**523, 525 and 525A Adelaide Street West - Zoning
Amendment - Refusal Report**

Date:	May 28, 2013
To:	Toronto and East York Community Council
From:	Director, Community Planning, Toronto and East York District
Wards:	Ward 20 – Trinity-Spadina
Reference Number:	12-117029 STE 20 OZ

Attachment 1: Site Plan

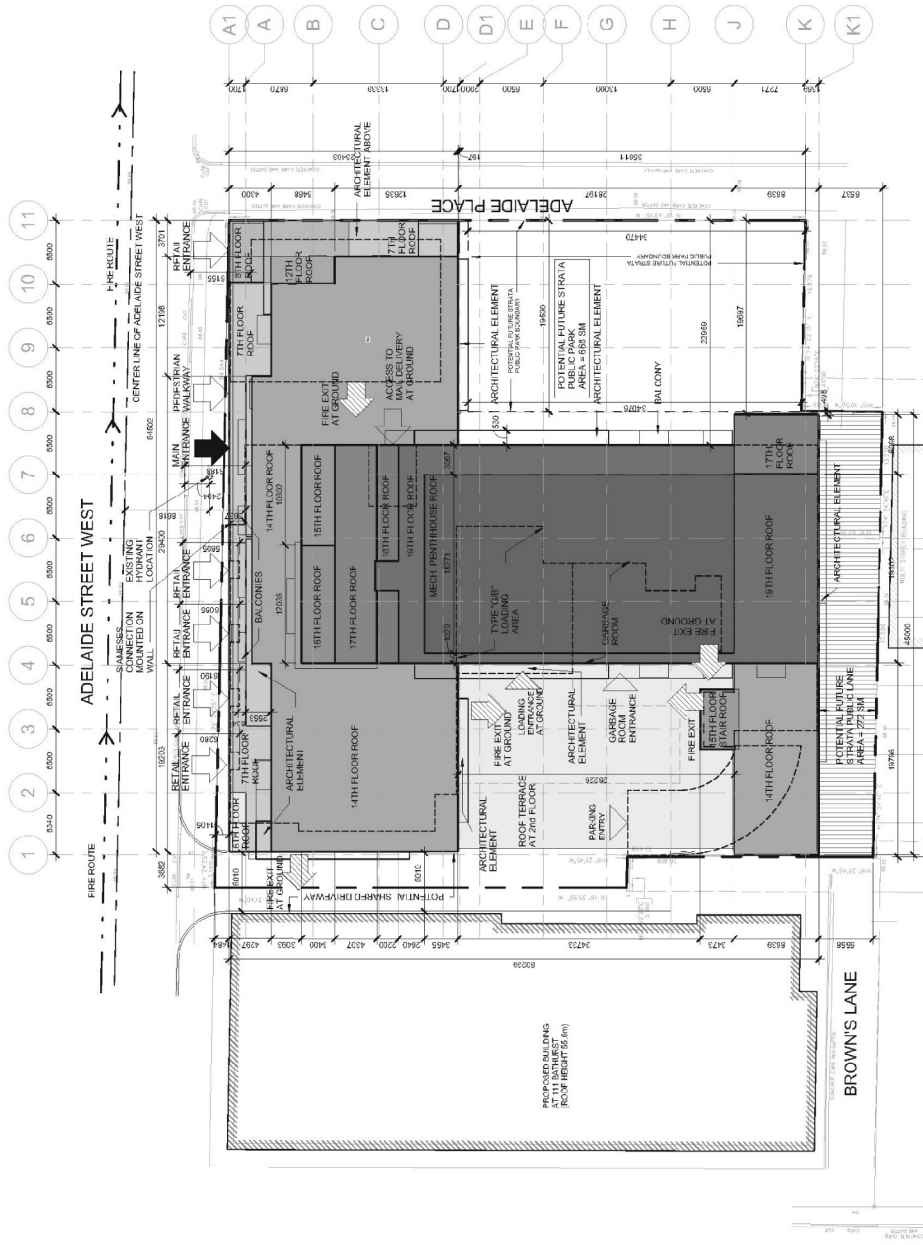
1. The Owner would be required to provide the 668m² strata land conveyance, as indicated on the submitted site plan (date stamped by City Planning Feb. 15/13), that would have a minimum soil depth of 1.5m.

Attachment 4: West Elevation

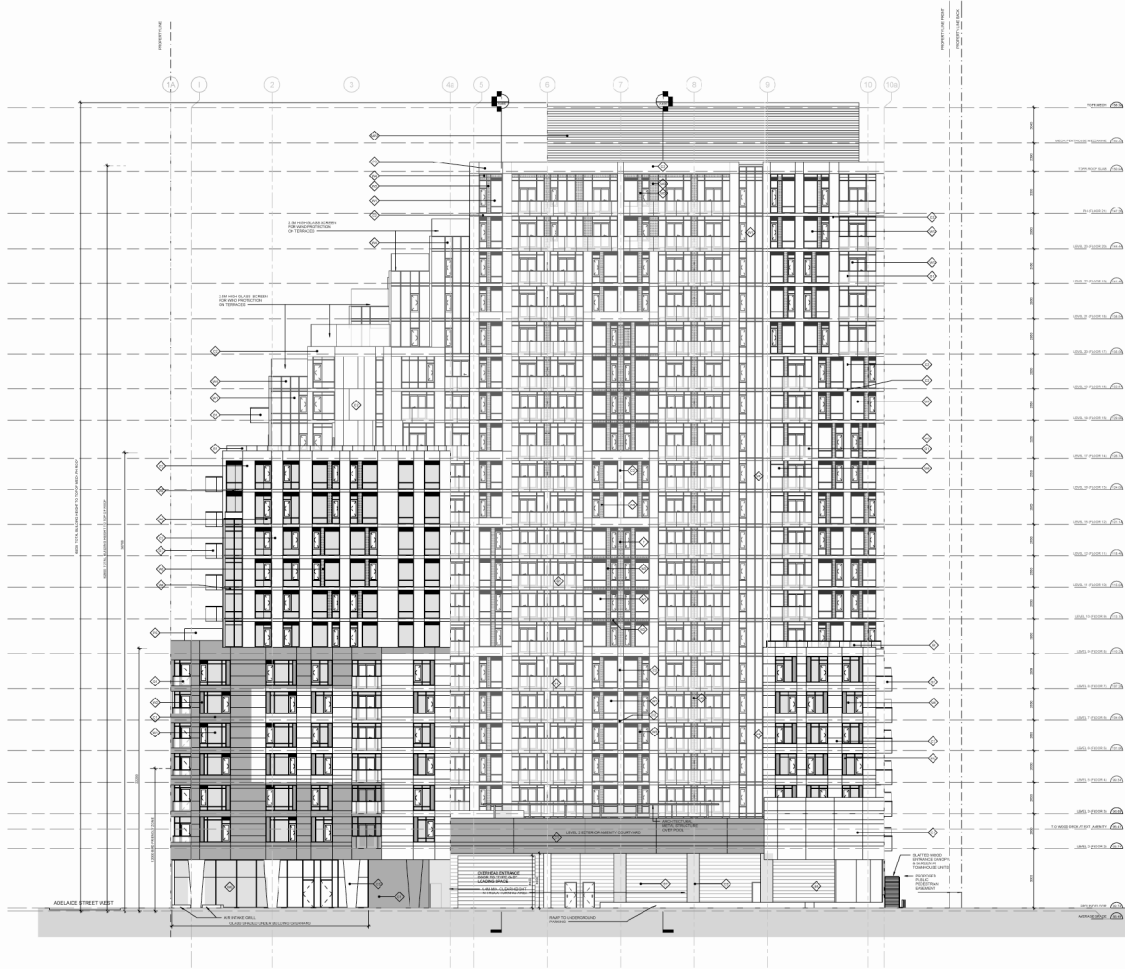
The applicants proposed building extends to the proposed public pedestrian easement at the south end of the site as described later in this report. At-grade, the screening for the proposed townhouse units facing the laneway extension appear to encroach onto the easement. There is a minimal setback (less than a metre when scaled from the plans) between the easement lands and the balconies for the 7-storey based building at the south end of the site. There is no stepback proposed in this location between the 7-storey base building and the additional 14-storeys which rise above the base building (see Attachment 4 – West Elevation). The applicants submitted floor plans also show

balconies which project beyond the face of the tower above the 7-storey base building. The resulting condition in this area is a 21-storey tower with a minimal setback (scaled from the plans at approximately 1.4 metres not including balcony projections) between the face of the tower and the proposed easement lands. The distance between the face of the proposed 21-storey tower and the mid-point of the easement lands is approximately 3.5 metres. The distance between the face of the proposed tower and the property line to the south is 5.5 metres. These measurements are exclusive of balcony projections.
